Access Compliance Report

Public Rights-of-Way

Intersection ID: 5304	Main Street: NORTHWOODS_FOREST_DR	Cross Street: PINE_MOUNTAIN_RD	Location: SE
ADA ID: AF05A9C31823	Ramp Type: Perp	Initial Pass/Fail: Fail	Overall Compliance: No
		Severity Score: 12.5	
Codes/Mitigation Info/Possible Solution		Field Measurements/Component Compliance

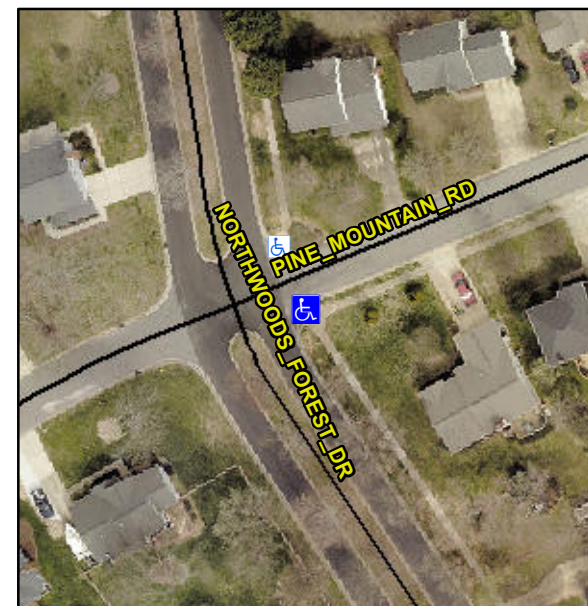
Not Found, R304.5.3

Compliance	Description	Data	Compliance	Description	Data
N/A	Ramp Length (in)	64.0	Yes	Ramp Slope (%)	6.5
Yes	Ramp Width (in)	48.0	No	Ramp XSlope (%)	5.5
N/A	Flare Type LT	N/A	N/A	Flare Type RT	N/A
N/A	Flare Slope LT (%)	N/A	N/A	Flare Slope RT (%)	N/A
N/A	Flare Traversable LT?	N/A	N/A	Flare Traversable RT?	N/A
N/A	Landing Length (in)	N/A	N/A	DWS Provided?	N/A
N/A	Landing Width (in)	N/A	N/A	DWS Contrast?	N/A
N/A	Landing Slope (%)	N/A	N/A	DWS Length (in)	N/A
N/A	Landing X Slope (%)	N/A	N/A	DWS Full Width?	N/A
N/A	Landing Curb? (Y/N)	N/A	N/A	DWS Offset (in)	N/A
N/A	Shared Landing?	N/A			
N/A	Gutter Ponding?	N/A	N/A	Gutter Slope (%)	N/A
N/A	Gutter Lip Ht (in)	N/A	N/A	Gutter X Slope (%)	N/A
N/A	Painted X Walk1?	No	N/A	Painted X Walk2?	N/A
	X Walk 1 Direction	To N		X Walk 2 Direction	N/A
N/A	X Walk 1 Width (in)	N/A	N/A	X Walk 2 Width (in)	N/A
	X Walk 1 Slope (%)	5.9		X Walk 2 Slope (%)	N/A
	X Walk 1 X Slope (%)	6.1		X Walk 2 X Slope (%)	N/A

Remove & Replace Entire Ramp.
